HISTORIC PRESERVATION REVIEW BOARD STAFF REPORT AND RECOMMENDATION

Landmark/District:	Cleveland Park Historic District	() Agenda
Address:	3615 Newark Street, NW	(x) Consent
		(x) Concept
Meeting Date:	October 27, 2011	(x) Alteration
Case Number:	11-519	() New Construction
Staff Reviewer:	Amanda Molson	() Demolition
		() Subdivision

Owners George & Nora Stavropoulos, with drawings prepared by Mr. Stavropoulos, request concept approval for front porch reconstruction and a rear addition to 3615 Newark Street, NW in the Cleveland Park Historic District.

Photo by the HPO (2004), showing remaining front porch elements

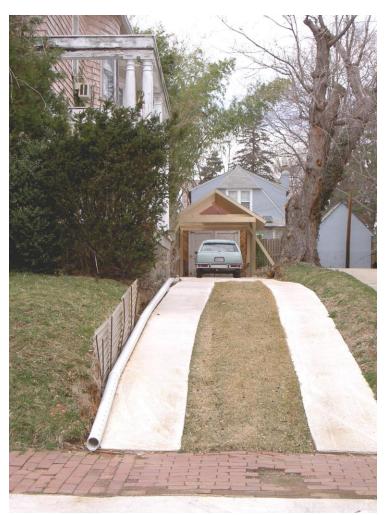
Reconstruction of the front porch will be a tremendous benefit to the property and to the streetscape. The remaining columns and railing, the 2004 photo of the property, and other similar properties in the neighborhood provide ample clues about the original design. The reconstructed porch, as shown in the plans, is a very close match to the original porch. Details of the replacement columns, specifically with regard to their width, should be specified in the final construction drawings; the columns shown in the plans appear to be more substantial in girth than those that remain on the porch.
